Local Planning Panel

1049, 1051 and 1053-1055 Bourke Street, Waterloo

D/2019/1082

proposal

street frontage height

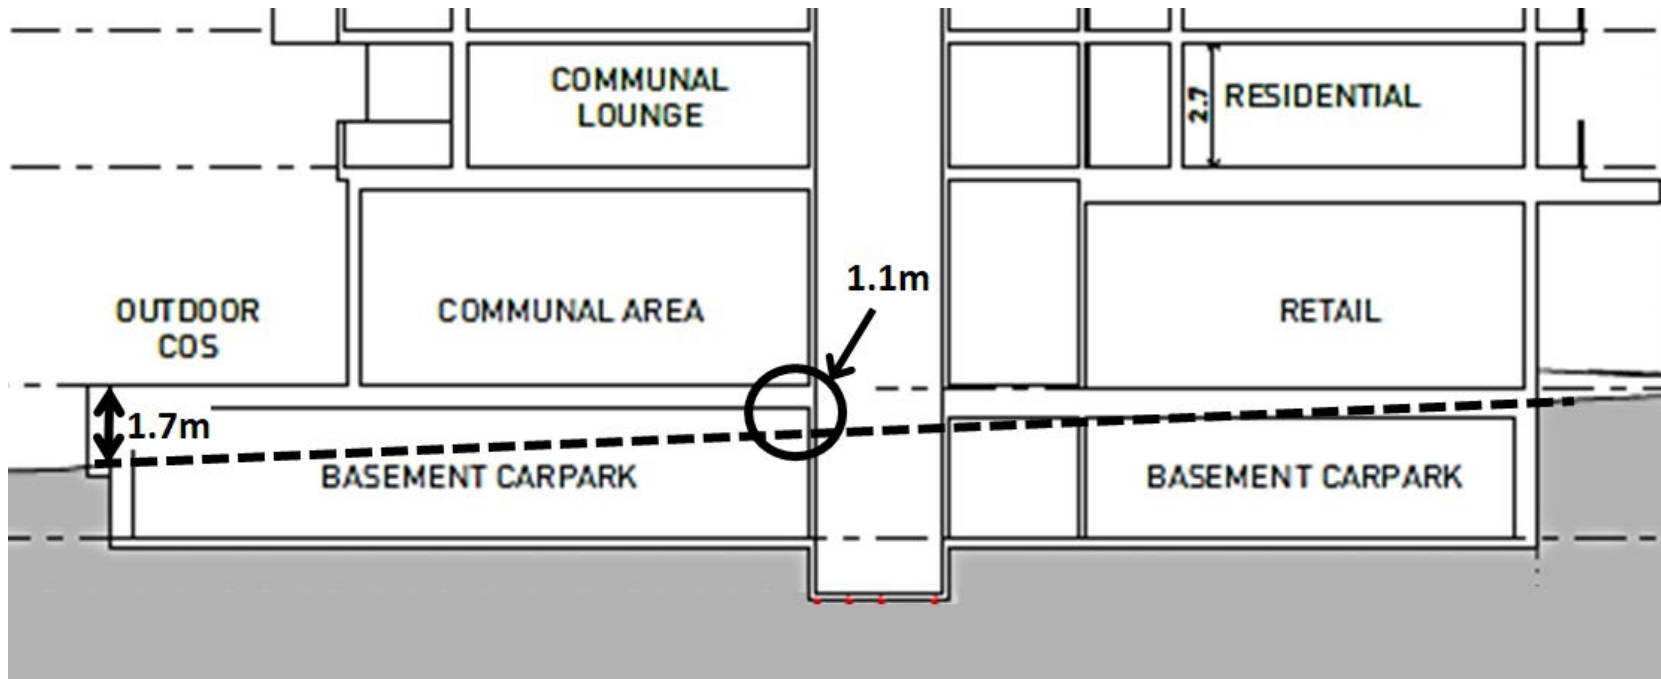
- DCP requires development in locality to reinforce pedestrian scale and provide good levels of solar access to the public domain
- DCP requires development to respond to street frontage height of adjacent buildings
- subject DA will establish precedent for under-developed adjacent sites
- condition recommended for development to provide 4 storey street frontage height

deep soil and car-parking

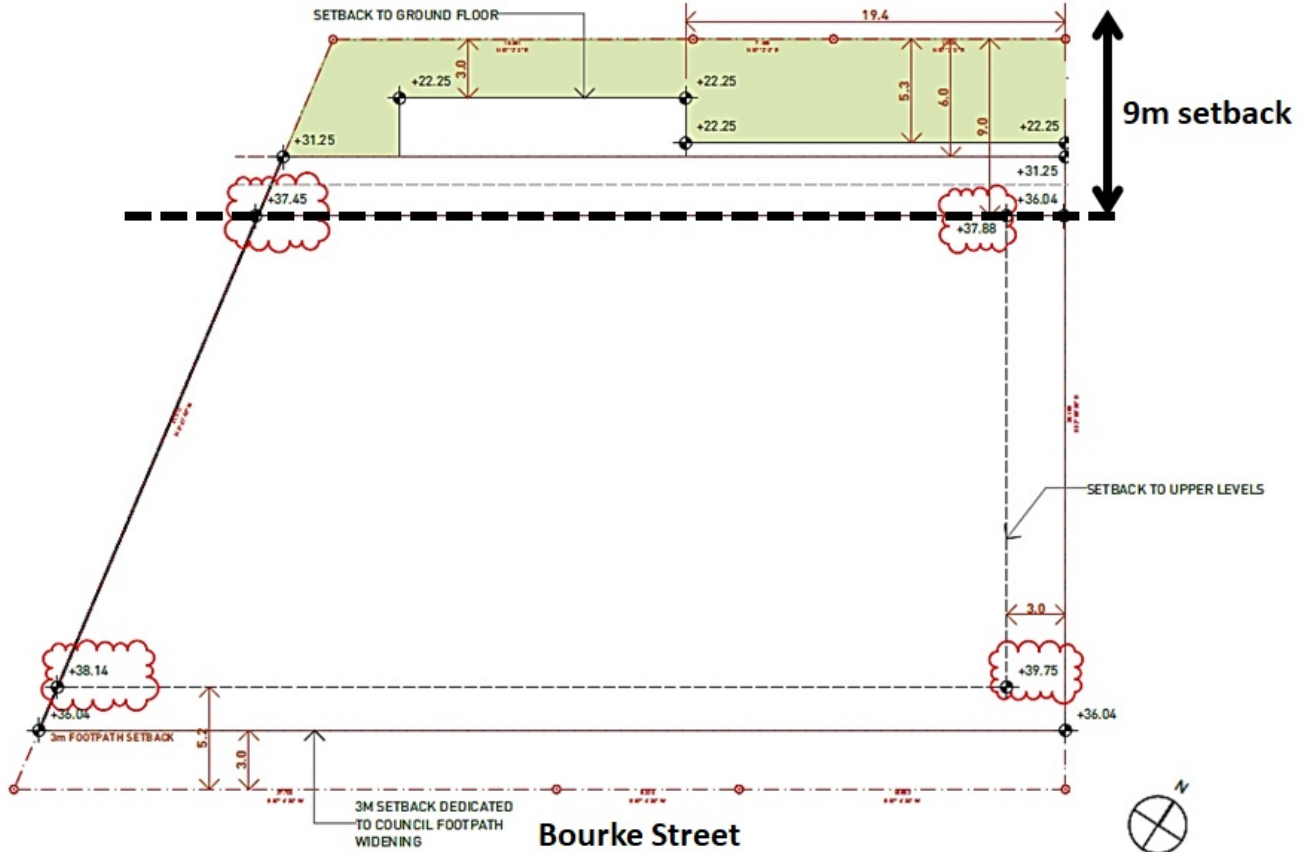
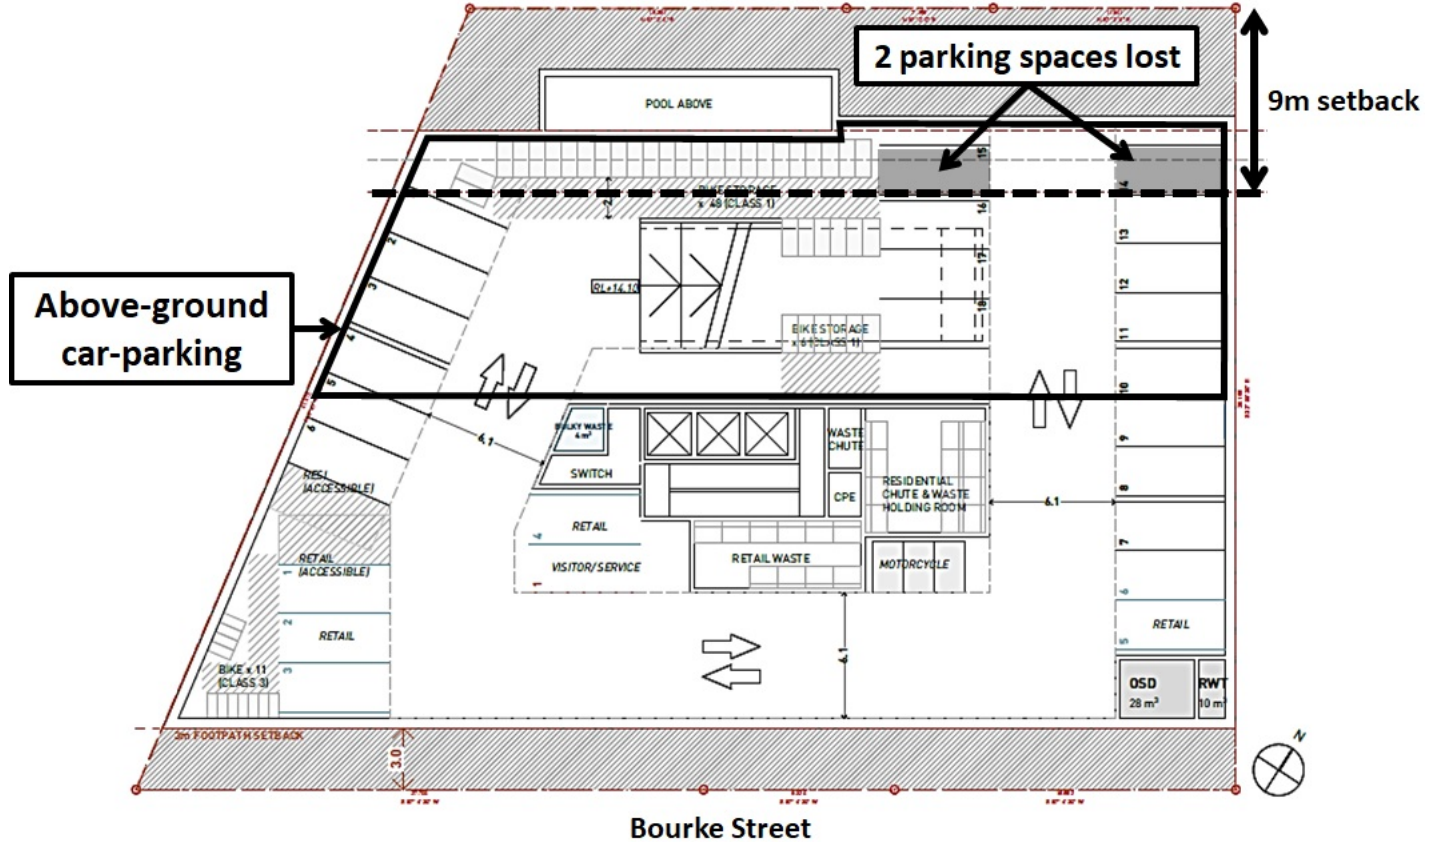
- site is close to Green Square station, buses and cycle paths
- development could function with only service vehicle access
- half of basement floor plate is above ground and exceeds:
 - DCP max. 6-storey height control
 - DCP max. 50% above ground car parking control
- under-sized and awkwardly configured deep soil area
- condition is recommended for envelope to be set back 9m from rear boundary to provide deep soil and reduce above-ground car parking

encroachment on public domain setback

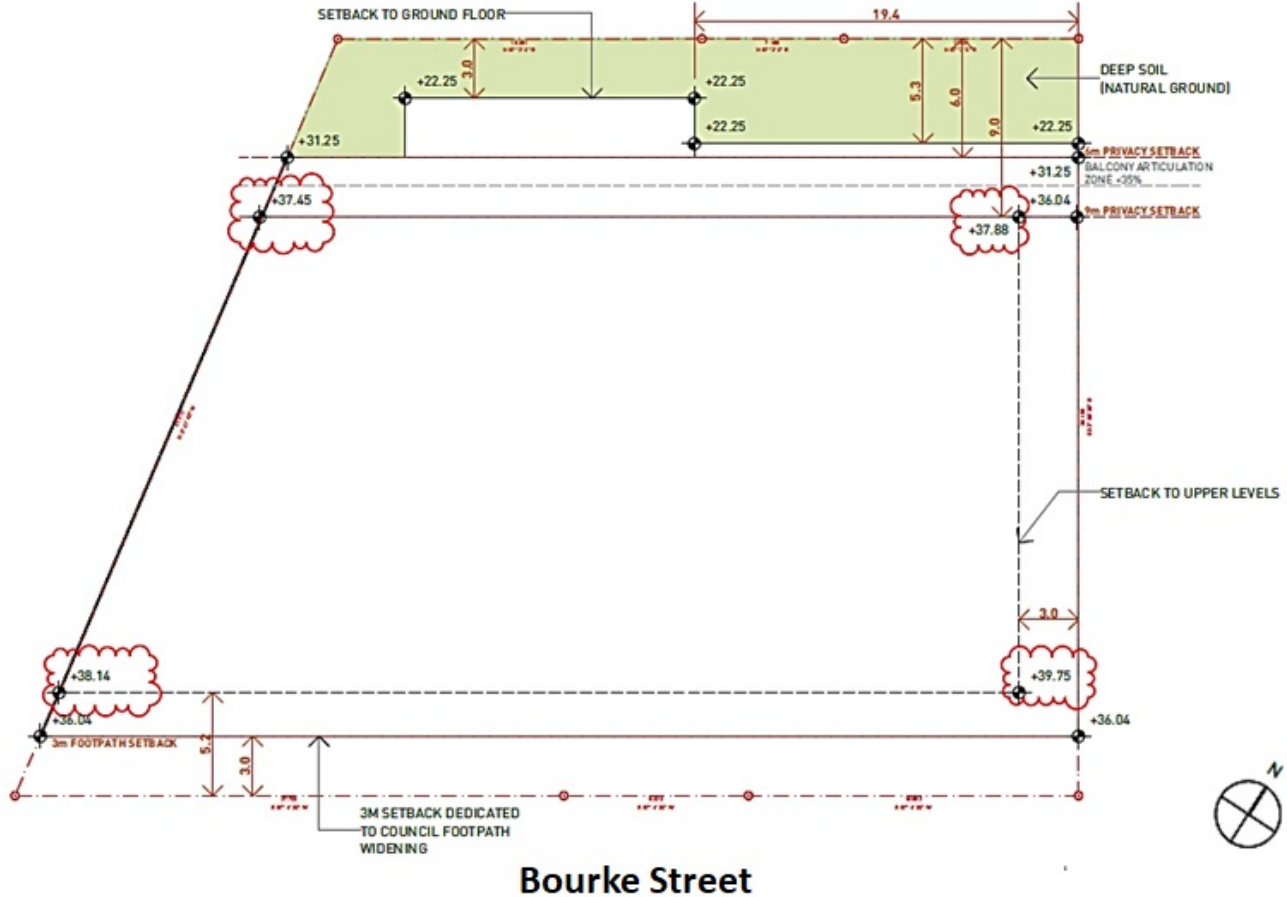
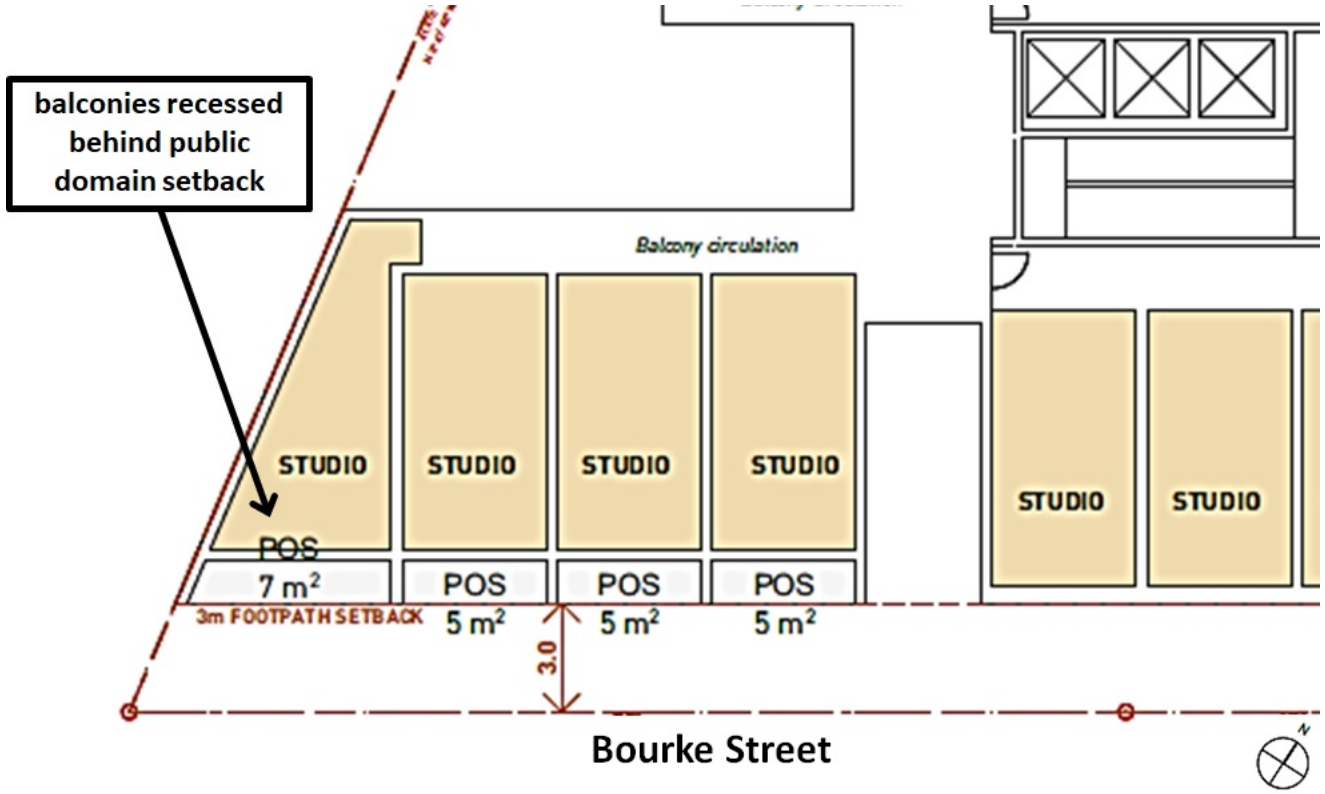
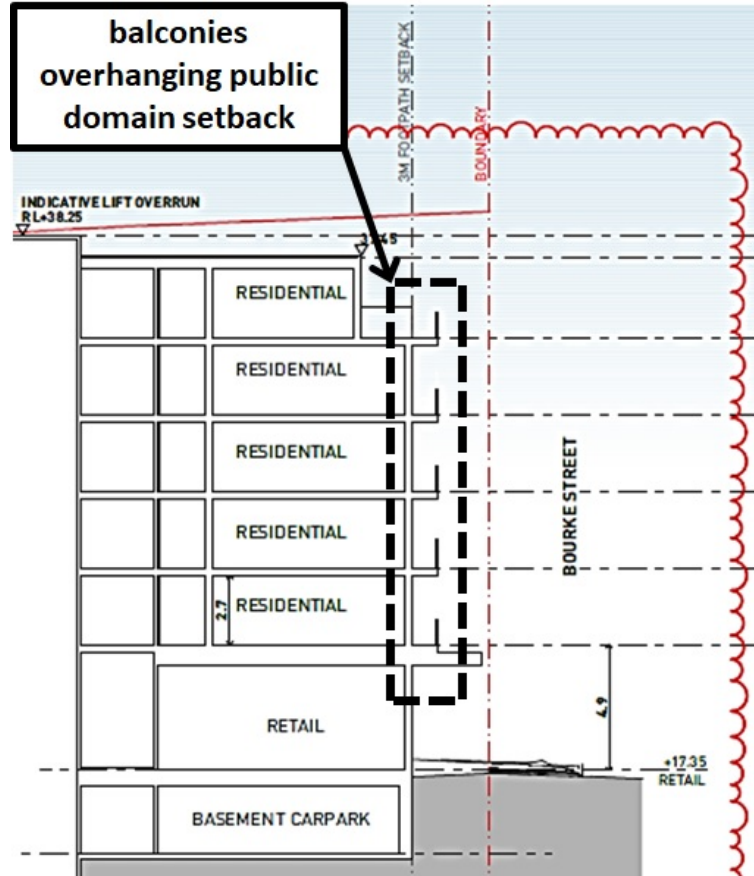
- envelope is setback 3m to provide footpath widening to Bourke Street
- in plan reference scheme balconies are recessed behind 3m setback
- in section reference scheme balconies overhang 3m setback
- condition recommended to ensure balconies and other facade elements do not encroach on public domain
